North Wales Wind Farm Connection

Deadline 10 Representation

Robin Barlow BSc(Physics), PhD(Theoretical Physics) (Your reference: 10031190)

TOWN AND COUNTRY PLANNING ACT 1990
APPEAL BY SP MANWEB PLC
SITE ADDRESS: CLOCAENOG FOREST, SARON, DENBIGH, DENBIGHSHIRE
REF: APP/R6830/A/15/3134331

Schedule 1
Comparison Plan

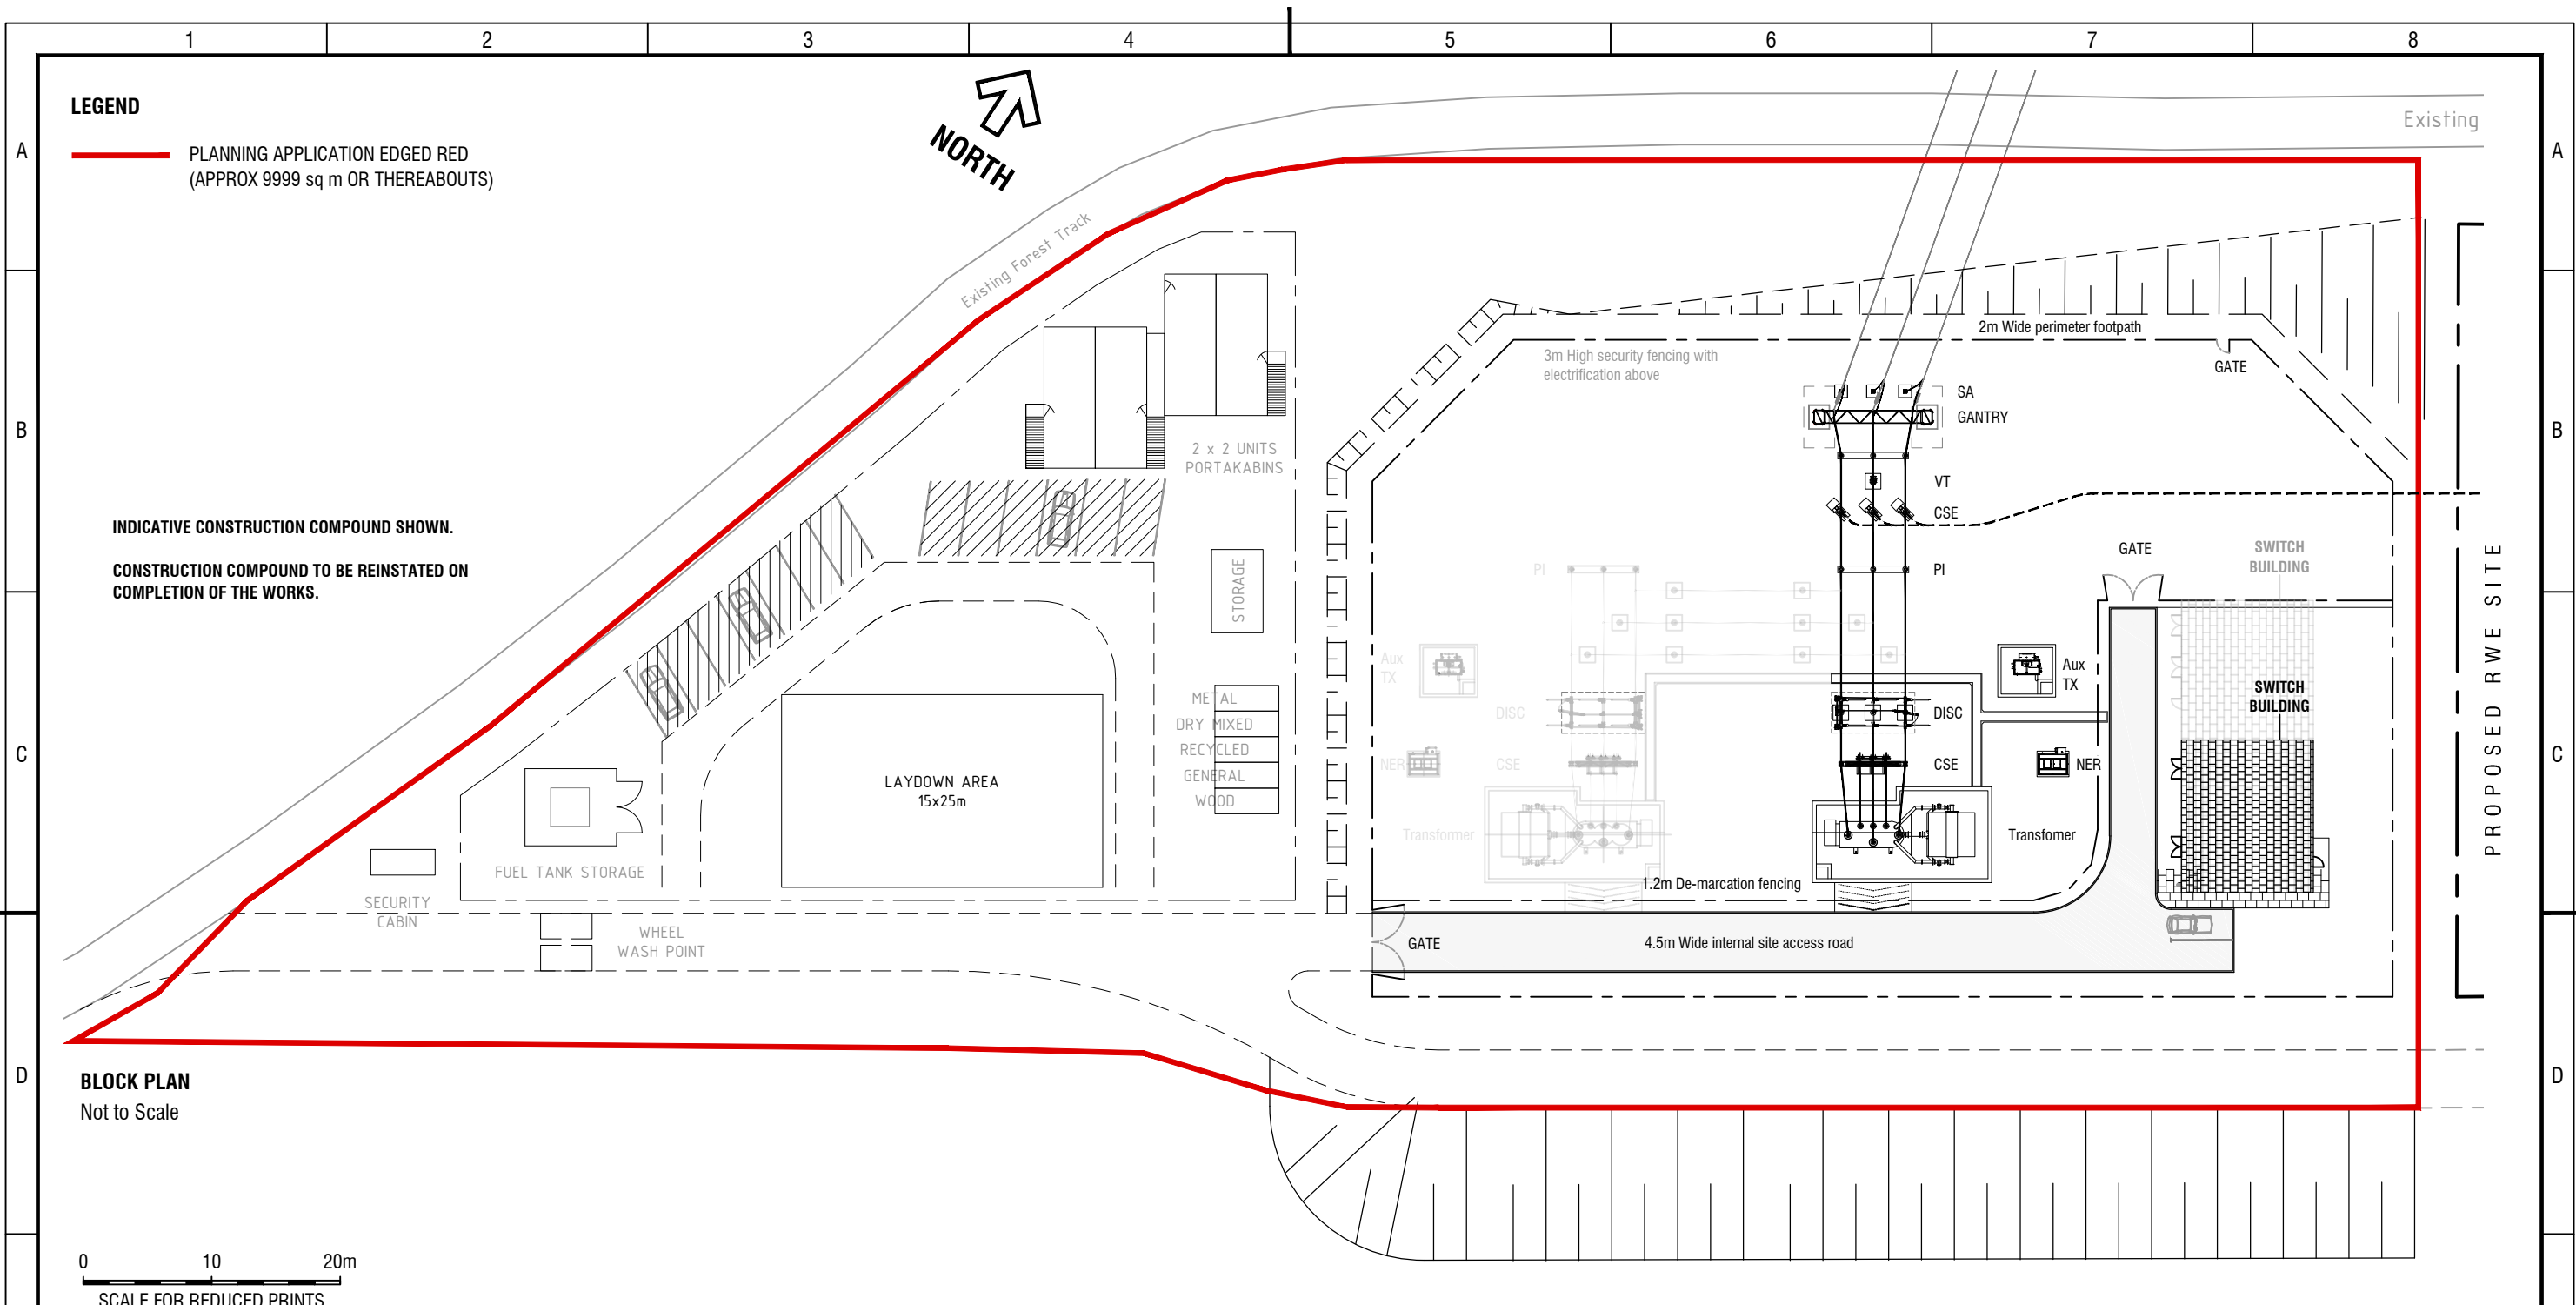
On 30th November RWE, one of the two remaining wind farms operators, notified SP Manweb that they themselves were going to install a 90 MW 33kv/132kv transformer (and 33kv switchgear) in their own substation next door to SP Manweb. They have had planning permission for this all along. They will now deliver their electricity to the NWWFC via a 132kv cable that only needs a simple uplink onto the NWWFC just before the gantry / terminal pole (see layout diagram in the Agents letter).

Now the point of interest for the NWWFC is not the revised site layout of the substation as given in the letter, but in the issue of the earthwire carried by the NWWFC and deemed essential by SP Manweb, with the consequence that a HDWP rather than a Trident Pole solution is required.

The RWE substation now handles the lions share of the NWWFC electricity (80MW to 45MW in the SPM substation). But, RWE does not appear to be using the earthwire of the HDWP and thus must (almost certainly) be earthing its substation within its compound. Mr Westmorland-Smith for SP Manweb, confronted with this at the substation appeal hearing today, seemed to confirm this (along the lines RWE has had planning permission and that must have been for a safe substation).

So if RWE has a local earthing scheme for its 80MW substation, in spite of the “high” resistivity of the ground, then SP Manweb must be able to use a similar earthing solution for its 40MW substation. Therefore the earthline on the NWWFC is not technically necessary.

SP Manweb need to clarify all this.

The practical implication of this request is that there is no longer a need for one of the transformers and associated outdoor equipment within the Proposed Development. As a consequence, the size of the Control Building can be reduced

To assist the Inspector, SP Manweb has prepared a comparison drawing in Schedule 1 of this letter which illustrates the proposed changes.

It has always been SP Manweb's position that two 132kV transformers are required to facilitate the connection of the Brenig and RWE wind farms to the 132kV Overhead Line. Instead of both transformers being located within the Proposed Development, the revised design is for one transformer to be located within the Proposed Development and one transformer within the RWE substation. As mentioned above, the RWE transformer was included in the cumulative assessments carried out by SP Manweb in respect of the Proposed Development.
